PROJECT : HONOAPIILANI HIGHWAY
Kahana to Alaeloa

PROJECT NO.: F-030-1(13)

DRAINAGE

STATE OF HAWAII
DEPARTMENT OF TRANSPORTATION
LAND TRANSPORTATION FACILITIES DIVISION
DRAINAGE & IRRIGATION PLAN
HONOAPIILANI HIGHWAY
Kahana to Aiealoa
F.A. Proj. No. F-030-1(13)

SHEET NO. 21 OF 8 SHEETS

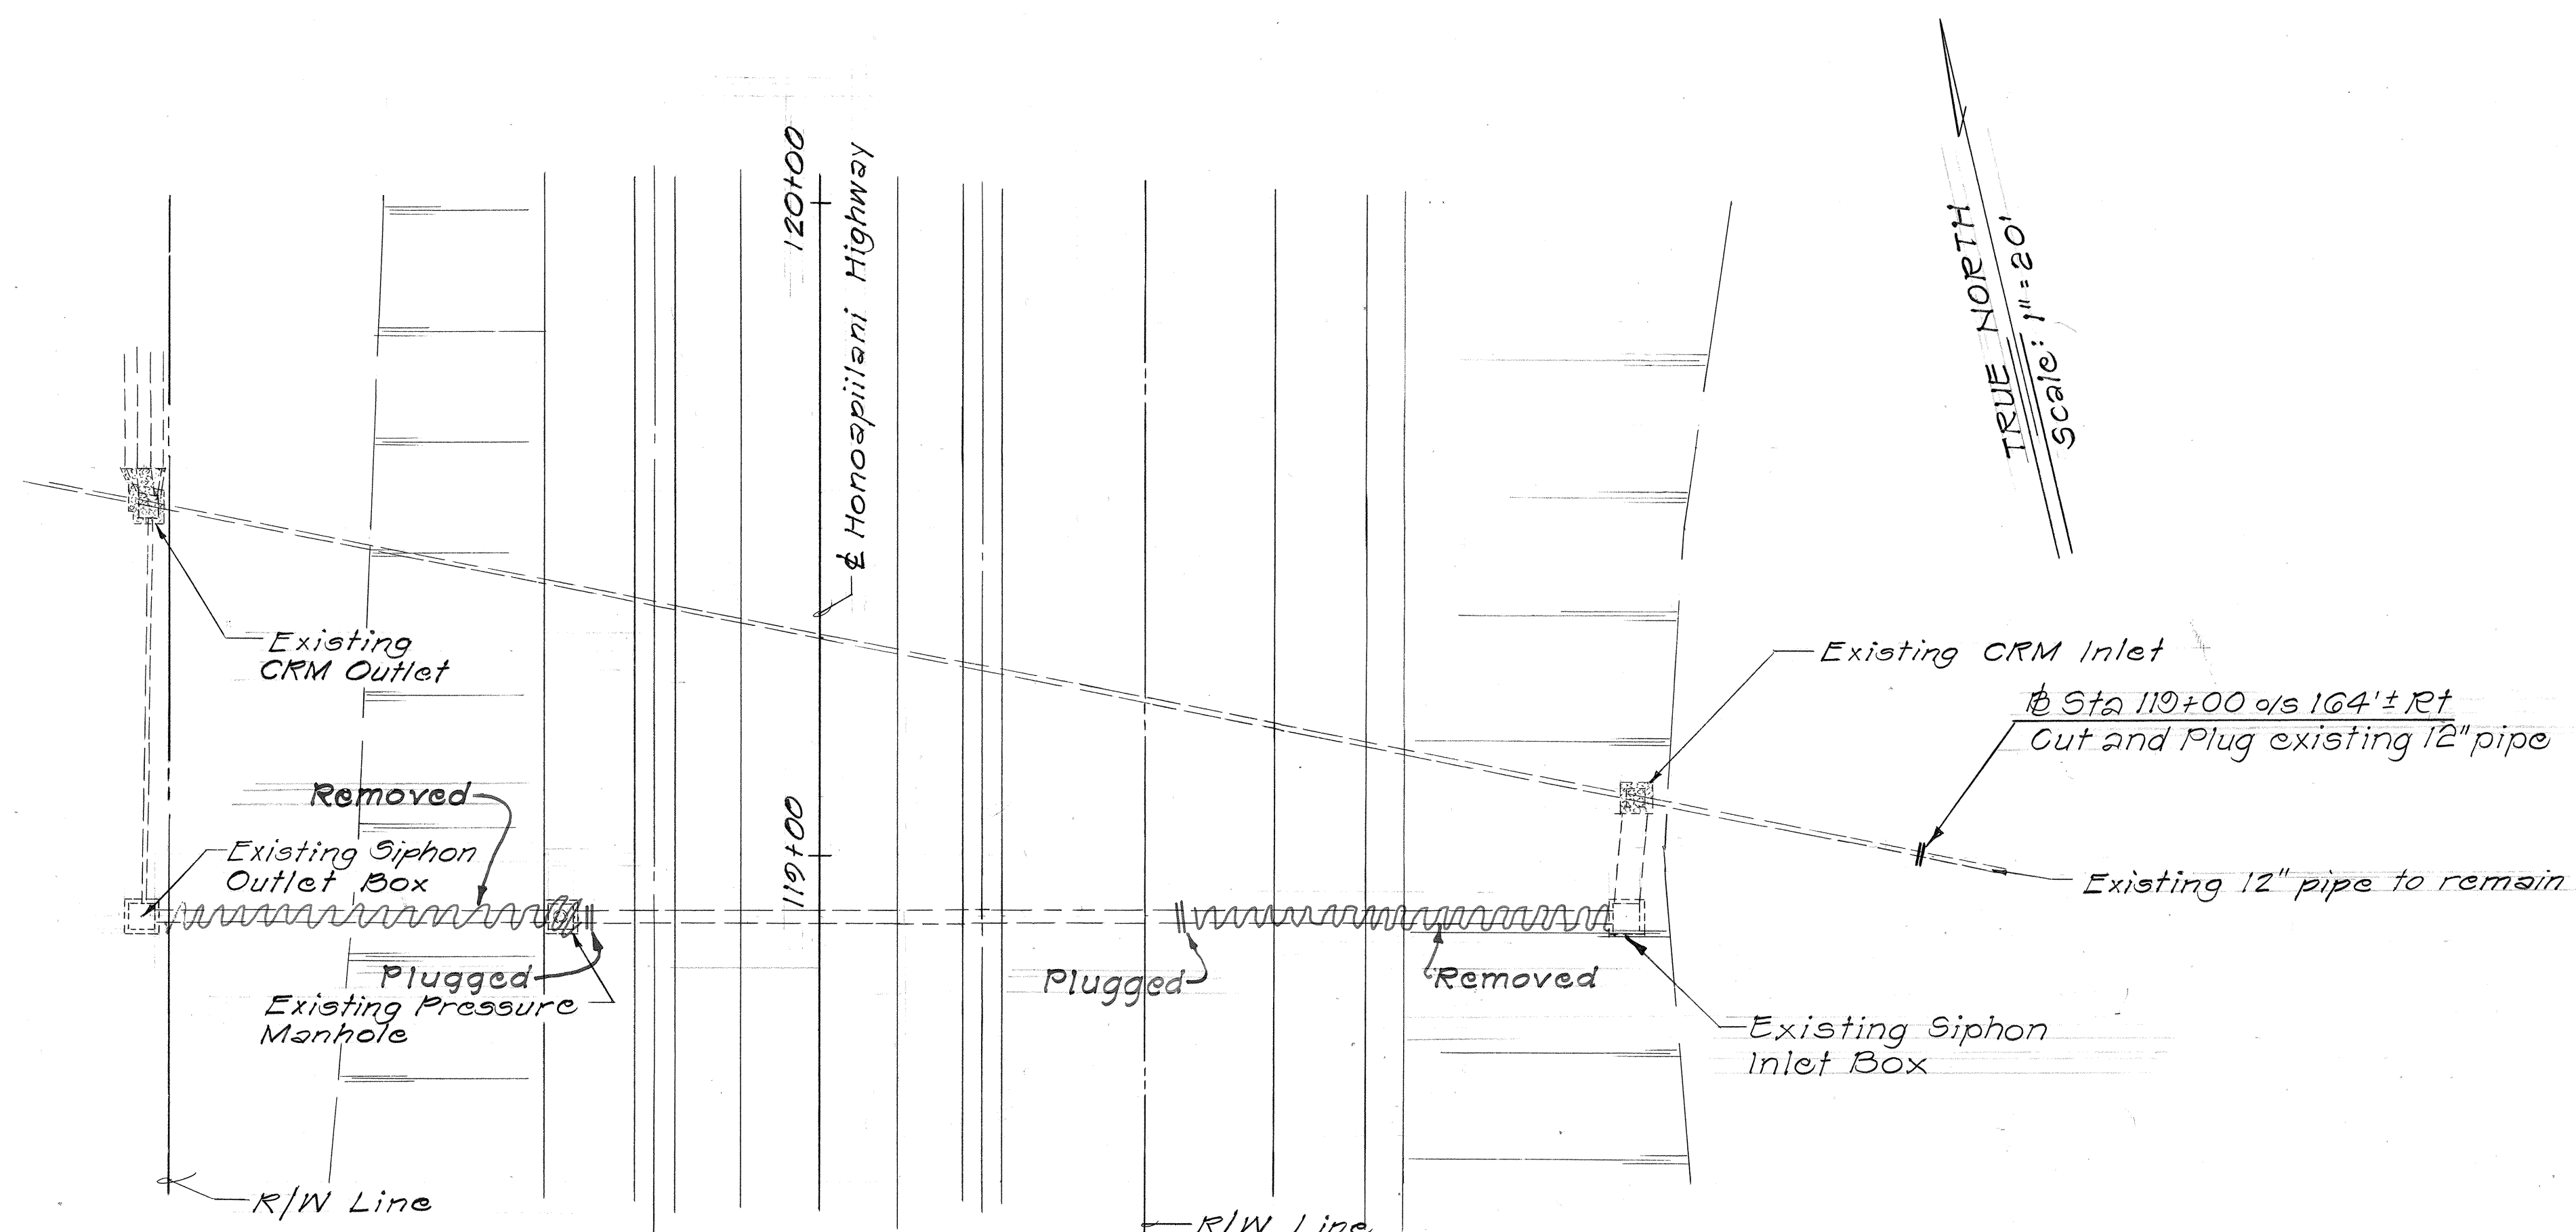
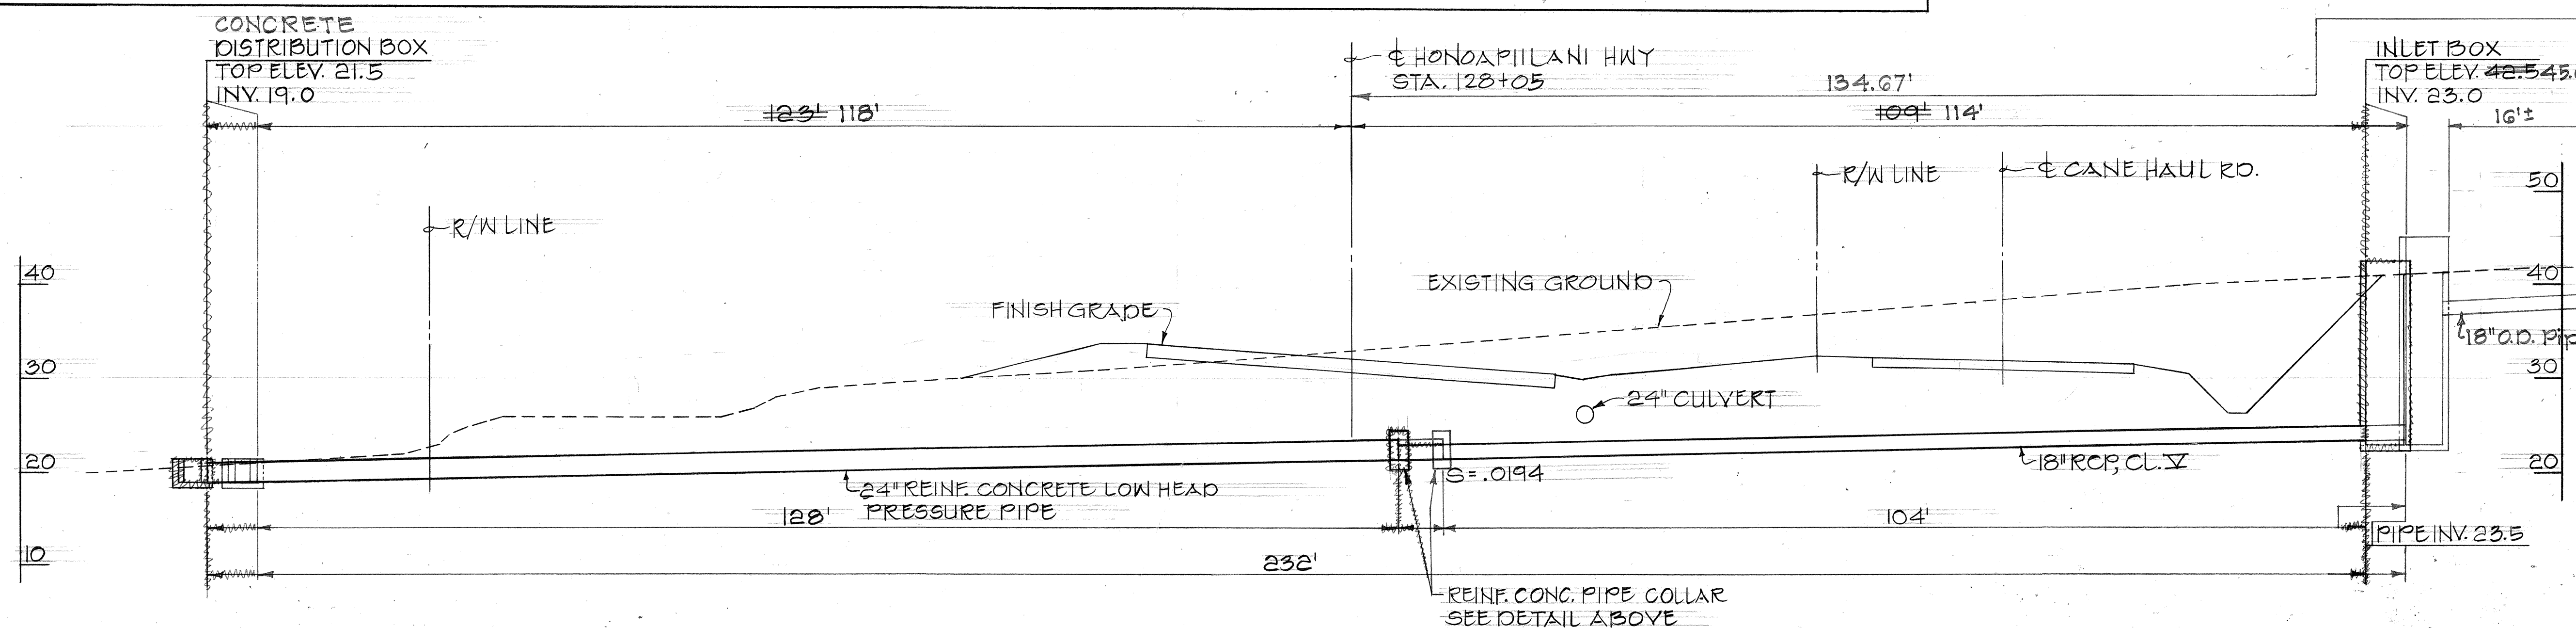
13 Nov 79 Tracing revised to show profile of crossing at & Sta. 128+05. Delete siphon inlet box (Sta. 119+00 o/s 164' Rt), siphon outlet box (Sta. 119+00 o/s 132' Rt) and pressure manhole (Sta. 119+00 o/s 42.5' Rt). Delete notes #1 to #6. Delete 24" siphon pipes. Cut and plug existing 12" irrigation pipe at & Sta. 119+00 o/s 164' Rt.
